ARE PACKARD SERVICE COSTS HIGH?

January 31, 1940, Vol. 6, No. 12. Take the flat hours of each item shown for each car and multiply it by the hourly rate charge prevailing in your city. To this figure add the material price shown.

INFLATING TIRES IN FENDER WELLS—ALL 18th SERIES

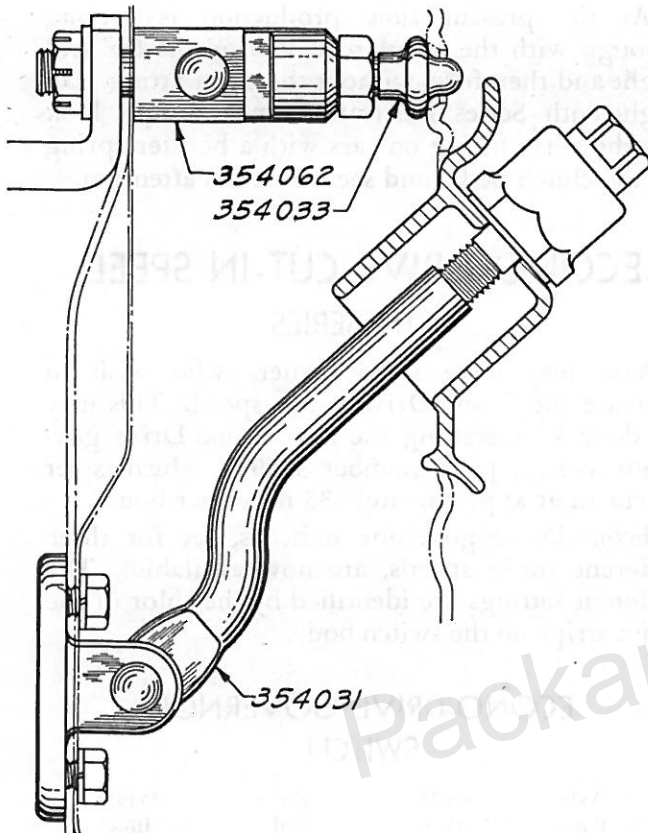
During production of the Eighteenth Series cars we made a change in the construction of the fender well wheel carrier so that the wheel is carried with the valve stem on the inside to permit inflation of the spare tires without removing the tire cover.

The installation of the new parts, which are shown in the illustration heavily shaded, is easy. The old brace and bracket assembly is removed and the new part 354062 and adjusting stud, 354033, substituted; the plain lock-nut and Marsden self-locking attaching nut removed from the old assembly being used again. The old lock rod and bracket assembly is removed and replaced with the new part 354031, the old attaching screws being used again. When the wheel is mounted on the carrier it should be mounted with the valve stem facing in and slightly to the rear of center so that it will not be covered by the tire cover.

This improvement in design may be applied to earlier cars where desired. All necessary parts are included in part 356352 Wheel Carrier (Side) Change-Over Equipment. The suggested list price is \$5.10. Each equipment contains the parts necessary to change over one wheel. If two wheels are to be changed over two equipments will be required.

WINTERFRONT—INSTALLATION IMPROVEMENT—18th SERIES

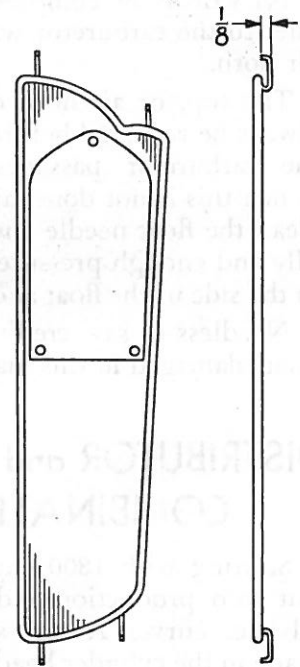
It has been found that the Fabric Winterfronts, PA 351294, may be attached to the radiator grille more securely if the ends of the attaching bars are bent back to form a hook. Installation is made by bowing the winterfront as formerly, but when installed the hooks catch on the edge of the grille frame, holding the winterfront securely in place.

The ends of the eight attaching bars should be bent, with a pair of pliers, to form a right hook of approximately $\frac{1}{8}$ " as shown.

DEFROSTER NOZZLE FIT

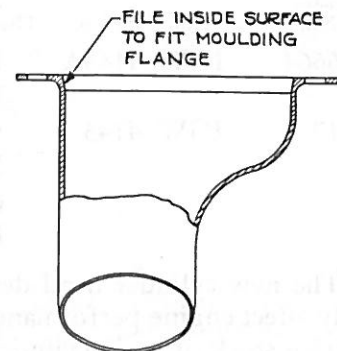
We recently changed the defroster nozzle to a die casting instead of a stamping. We now find that, due to the variation in the windshield moulding, in some cases the nozzle will not fit over the flange of this moulding. To secure a satisfactory fit, you may find it necessary to file out the casting slightly. Unless this casting fits up over the windshield flange, it will cut down the efficiency of the defroster considerably. Therefore, it is important that the casting be made to fit properly.
